Sheet 1 DF 3

Model: DA DP 4055

NEWMAR CORP
P.O. Box 30,
Nappanee, IN. 46550

Title: 12V WIRING DIAGRAM

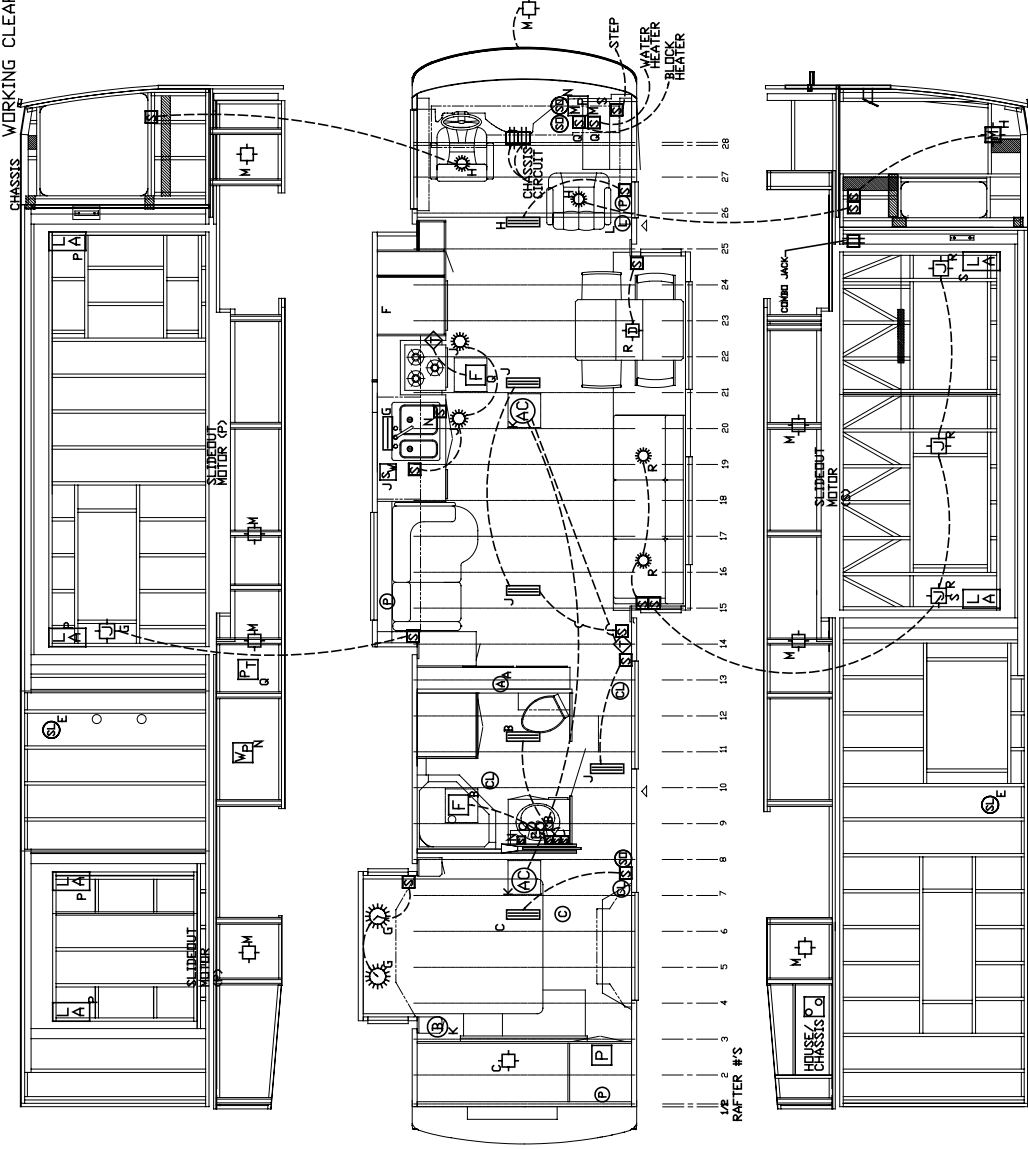
RevisionREMOVED HALOGEN LIGHT OVER DINETTE PER ECO 363/364

WALL MOUNTED READING LIGHT LOCATED ON FRONT DS AND DDS SIDEWALL REMOVED AND R.N.

REPLACED WITH A CEILING MOUNTED HALOGEN LIGHT ABOVE DRIVER AND PASSENGER SEAT PER ECO #202 5/20/08

ADDED THIRD WALL LIGHT PER MODEL LINE #731, MOVER WATER HEATER R.N.
